DUKE POWER COMPANY

June 1, 1984

Re: Catawba Nuclear Station, Unit 1
Docket No. 50-413
Draft Technical Specifications

This letter transmits our proposed revision to Draft Technical Specification 3/4.7.8 -- SNUBBERS. The justification for the revision was discussed between Mr. Fred Anderson and Mr. Horace Shaw of your staff and representatives of Duke in a meeting held on February 28, 1984. Subsequent discussions and written correspondence have not produced a final resolution acceptable to Duke. A summary of our position is attached.

FIGURE 4.7-1
SAMPLE PLAN 2) FOR SNUBBER FUNCTIONAL TEST

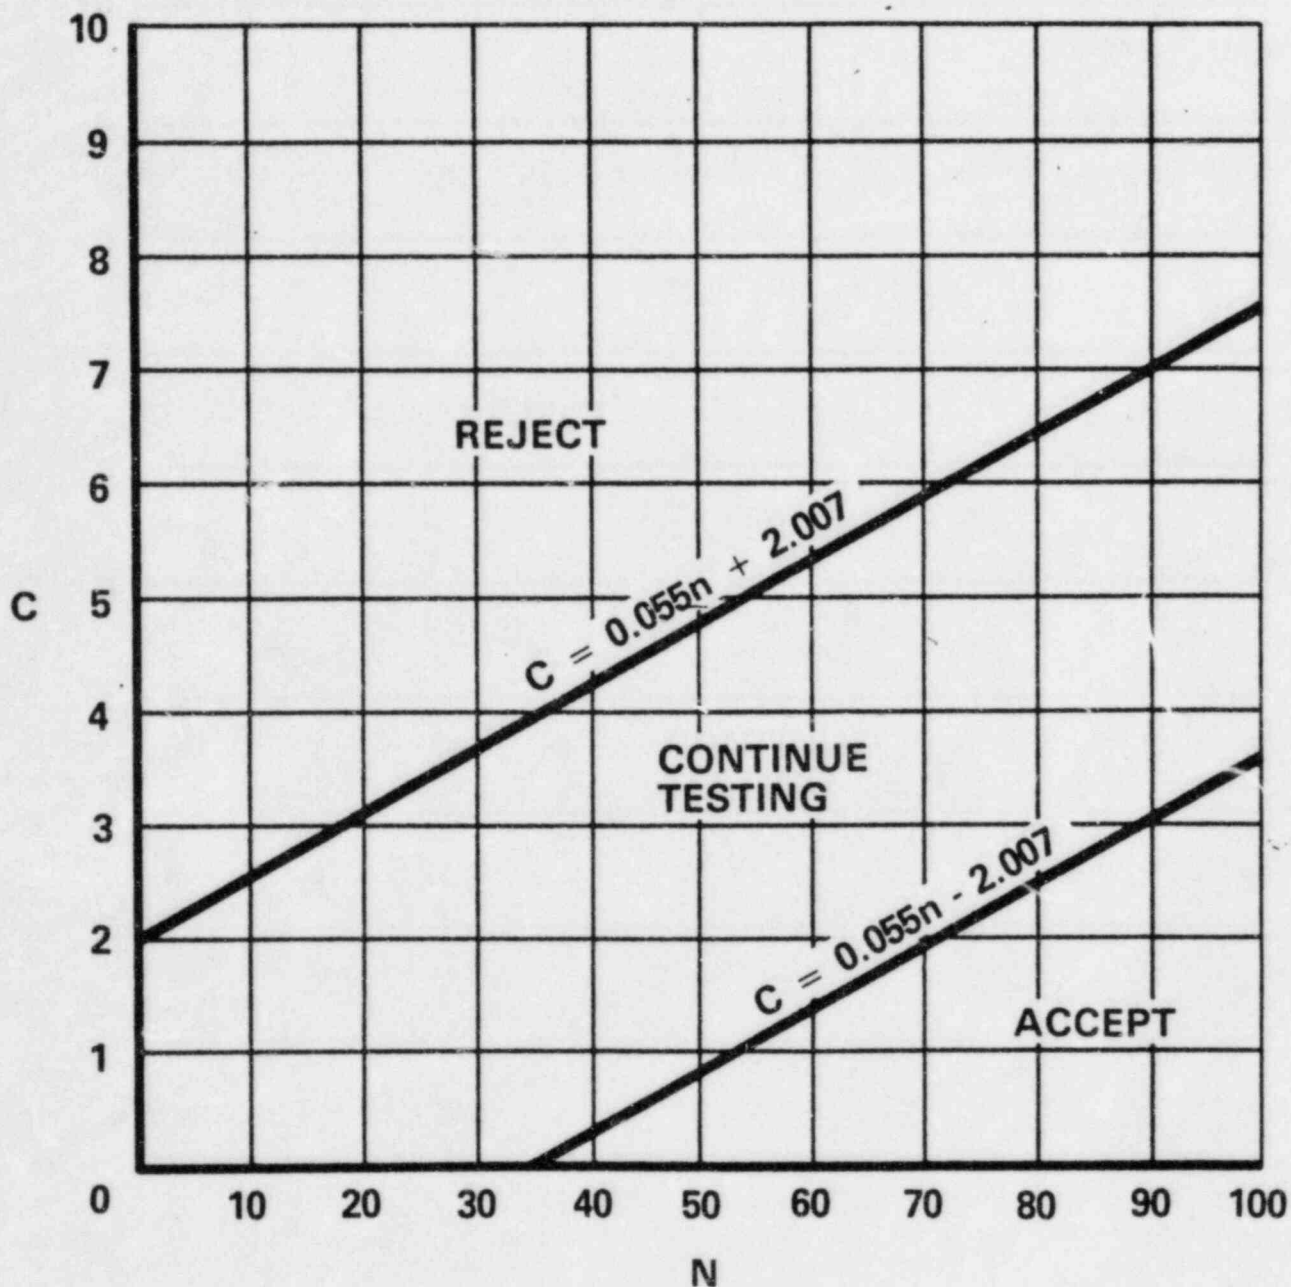
- 2) A representative sample of the snubbers required by Specification 3.7.8 shall be functionally tested in accordance with Figure 4.7-1. "C" is the total number of snubbers found not meeting the acceptance requirements of Specification 4.7.8f. The cumulative number of snubbers tested is denoted by "N." At the end of each day's testing, the new values of "N" and "C" (previous day's total plus current day's increments) shall be plotted on Figure 4.7-1. If at any time the point plotted falls in the "Reject" region all snubbers shall be functionally tested. If at any time the point plotted falls in the "Accept" region, testing of snubbers may be terminated. When the point plotted lies in the "Continue Testing" region, additional snubbers shall be tested until the point falls in the "Accept" region or the "Reject" region, or all the snubbers required by Specification 3.7.8 have been tested. Testing equipment failure during functional testing may invalidate that day's testing and allow that day's testing to resume anew at a later time, providing all snubbers tested with the failed equipment during the day of equipment failure are retested; or

Figure 4.7-1 was developed using "Wald's Sequential Probability Ratio Plan" as described in "Quality Control and Industrial Statistics" by Acheson J. Duncan.
